## **MEMORANDUM**

**File No.:** DRV18-00493

**Subject:** **ROSE HILL MIXED USE PROJECT CONCEPTUAL MASTER PLAN AND PROJECT DESIGN RESPONSE CONFERENCE**

**1** BUILDING D - SW ELEVATION AT 85TH

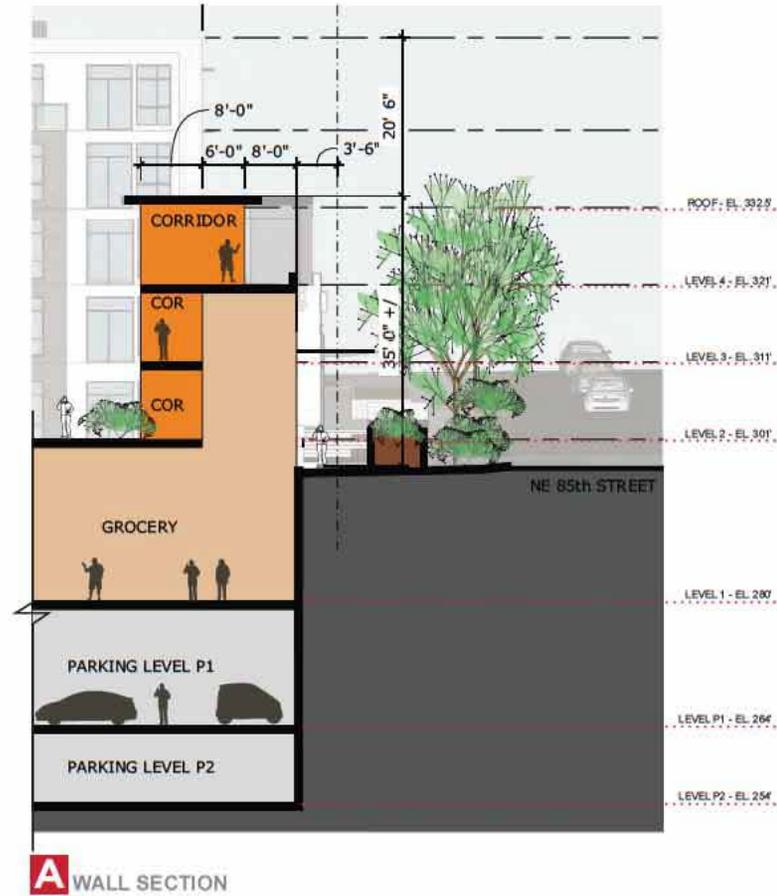
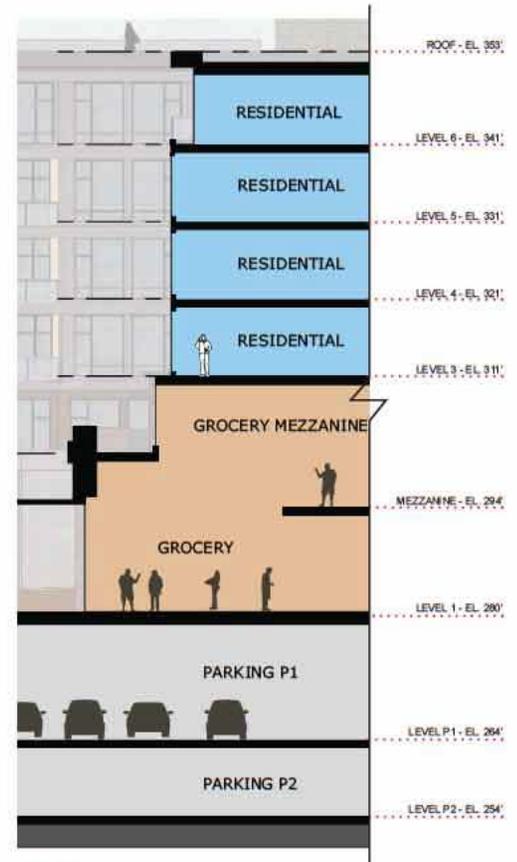
- The upper level treatment of Building D along NE 85<sup>th</sup> Street façade.
- Treatment of Building D façade near the U-Haul site.
- Larger scale elevations of each building to help with building by building review.
- Generic material details and treatments for each building.
- Additional parapet and roofline modulation.
- Onsite light study for courtyard and open space areas.
- Planter wall details and design for entry terrace.
- Design of loading dock along 122<sup>nd</sup> Avenue NE.
- Incorporate impacts of the U-Haul easement on the frontage and building design.

- The upper level treatment of Building D along NE 85th Street façade.
- Treatment of Building D façade near the U-Haul site.
- Larger scale elevations of each building to help with building by building review.

CONCEPTUAL DESIGN CONFERENCE CONCEPTS

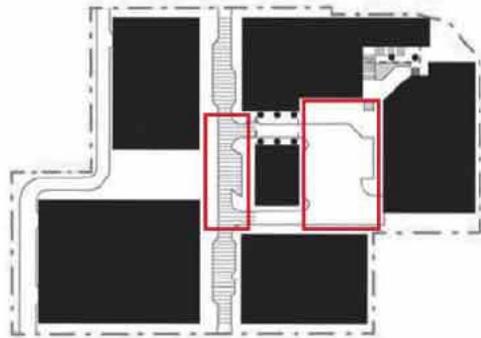
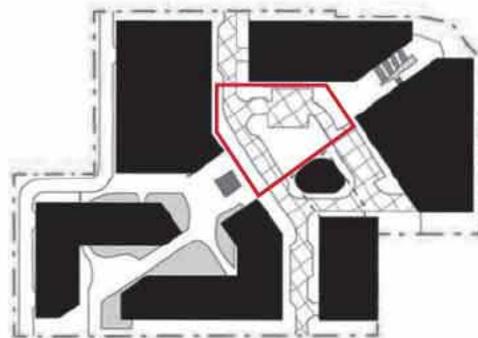
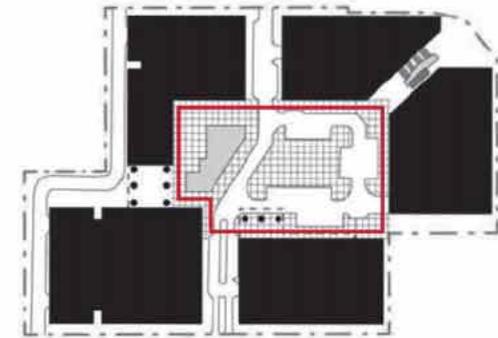
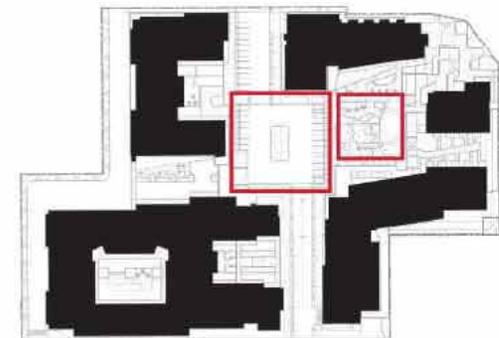
- Height of structure when viewed from the North.
- Interior of plaza should not be complex.
- Food services from grocery could engage 85th, activation is important.
- Entrance to U-Haul should not be too abrupt from 85th.
- Long walls along 120th and 122nd should be modulated.
- Travel through the site should be clear and friendly.
- We are encouraged to have the project face both inward and outward.
- Residential uses at sidewalk should be encouraged along 120th and 122nd.
- Strong interior plaza form is positive.
- Sun exposure to interior spaces is important.
